Work Order ID 146532

Item Name: GH1 Upgrade

DART SERVICE INSTRUCTION

TO AMEND INSTALLATION INSTRUCTIONS IIN-D117-762 REV. D AND
INSTRUCTIONS FOR CONTINUED AIRWORTHINESS ICA-D117-762 REV. 3

FIGURE 1 - GHU UPGRADE INSTALLATION

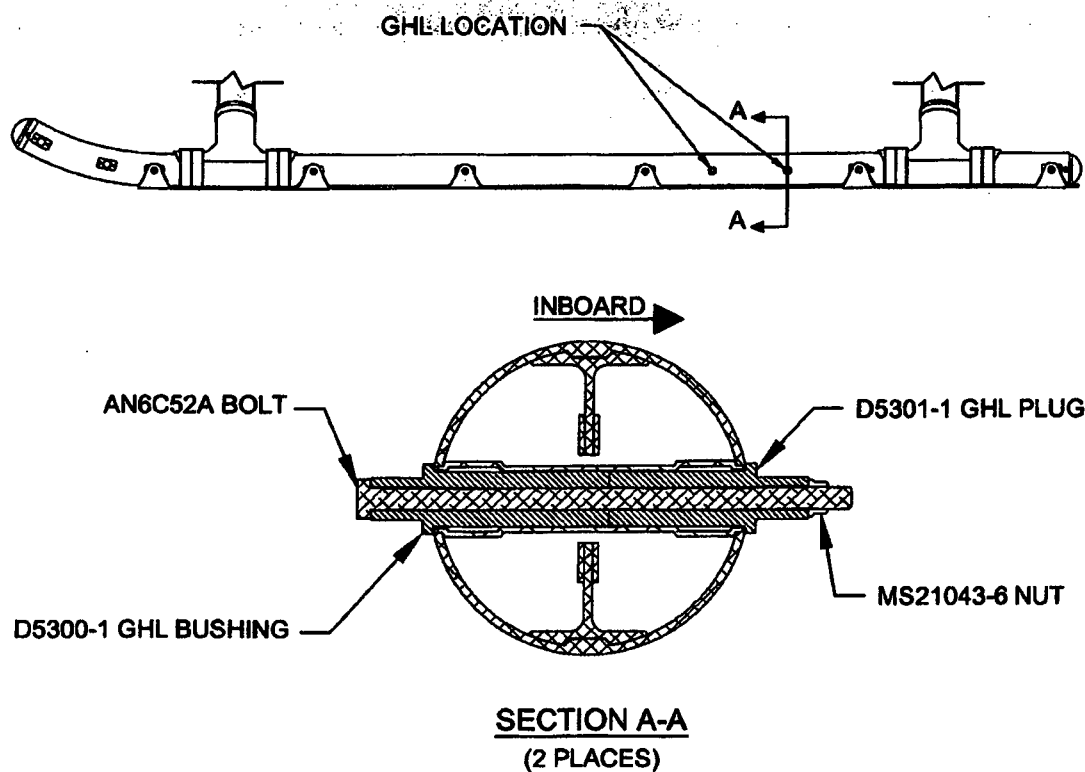
The purpose of this Dart Service Instruction (DSI) is to replace the ground handling lugs (D3864-1 Bushings, AN6C51A Bolts and MS21043-6 Nuts) on the D145-762-XXX Skidtubes with a structurally superior lug design. This service instruction only affects D145-762-043/-013/-113 Skidtubes at change 004 or earlier and D145-762-045/-015/-115 Skidtubes at change 001. It is highly recommended to install DSI 9731-011 GHL Upgrade Kit in order to prevent early structural failure of the D145-762-XXX Skidtubes. Each DSI 9731-011 GHL Upgrade Kit provides the necessary parts and hardware for installation on one skidtube.

- 2.1 Remove (qty 4) D3864-1 Bushings per Skidtube by removing (qty 2) AN6C51A Bolts and (qty 2) MS21043-6 Nuts
- 2.2 Loosely install (qty 2) D5300-1 GHL Bushing & (qty 2) D5301-1 GHL Plug wet with Proseal 890 or MIL-S-8802 Class B2 Sealant in location shown in Figure 1.
- 2.3 Install AN6C52A Bolts and (qty 2) MS21043-6 Nuts in accordance with Figure 1. Clean up squeezed out Proseal and apply fillet seal around D5300-1 & D5301-1.
- 2.4 Torque AN6C52A Bolts 160 - 190 in-lbs (18.1 - 21.5 N-m).
